Access Compliance Report

Public Rights-of-Way

Intersection ID: 32300	Main Street: AUBURN_TOP_LN	Cross Street: HAZELVIEW_DR	Location: NE
ADA ID: 63A972DB4315	Ramp Type: PerpDiag	Initial Pass/Fail: Fail	Overall Compliance: No
			Severity Score: 21.25

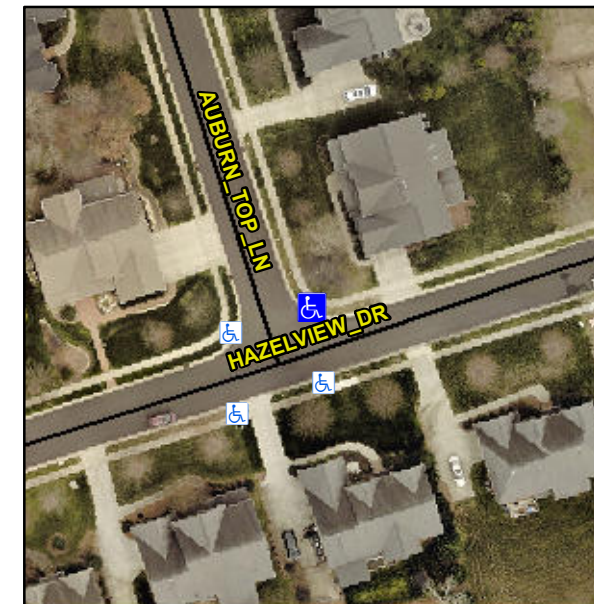
Not Found, R304.5.1, R304.5.3

Compliance	Description	Data	Compliance	Description	Data
N/A	Ramp Length (in)	50.0	Yes	Ramp Slope (%)	5.6
No	Ramp Width (in)	47.0	No	Ramp XSlope (%)	6.6
N/A	Flare Type LT	N/A	N/A	Flare Type RT	N/A
N/A	Flare Slope LT (%)	N/A	N/A	Flare Slope RT (%)	N/A
N/A	Flare Traversable LT?	N/A	N/A	Flare Traversable RT?	N/A
N/A	Landing Length (in)	N/A	N/A	DWS Provided?	N/A
N/A	Landing Width (in)	N/A	N/A	DWS Contrast?	N/A
N/A	Landing Slope (%)	N/A	N/A	DWS Length (in)	N/A
N/A	Landing X Slope (%)	N/A	N/A	DWS Full Width?	N/A
N/A	Landing Curb? (Y/N)	N/A	N/A	DWS Offset (in)	N/A
N/A	Shared Landing?	N/A			
N/A	Gutter Ponding?	N/A	N/A	Gutter Slope (%)	N/A
N/A	Gutter Lip Ht (in)	N/A	N/A	Gutter X Slope (%)	N/A
N/A	Painted X Walk1?	No	N/A	Painted X Walk2?	No
	X Walk 1 Direction	To W		X Walk 2 Direction	To S
N/A	X Walk 1 Width (in)	N/A	N/A	X Walk 2 Width (in)	N/A
	X Walk 1 Slope (%)	6.5		X Walk 2 Slope (%)	0.1
	X Walk 1 X Slope (%)	0.0		X Walk 2 X Slope (%)	7.3

Remove & Replace Curb Ramp With Two New Directional Ramps or Equivalent.
